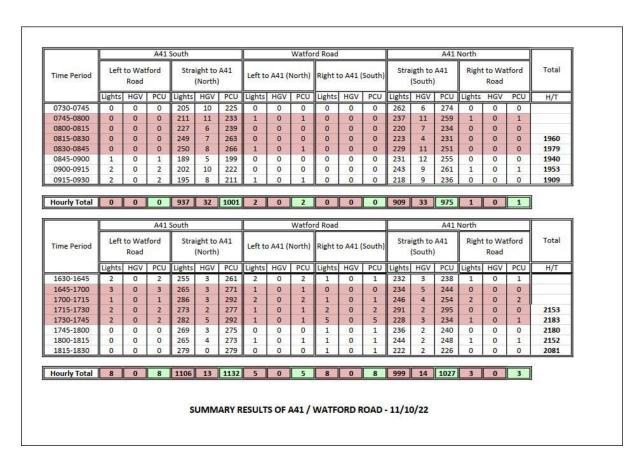
So how many vehicles are there on the main road in rush hour? / how many gaps in the traffic long enough to enable vehicles to cross the road and enter & exit the site? (how many gaps per minute in rush hour?)

The estimated number of trips associated with the proposed development and modelling of the proposed access arrangement, based on recorded vehicle trips growthed up to the year 2036, are provided within the submitted Transport Assessment. The recorded vehicular movements along the A41 during the peak periods are presented below for ease.

This demonstrates that during the busiest AM peak there are 1,001 vehicles travelling north along the A41 and 975 travelling south. During the busiest PM peak, this recorded 1,132 vehicles travelling north along the A41 and 1,027 travelling south. As previously highlighted, these flows were growthed up to the year 2036 and the
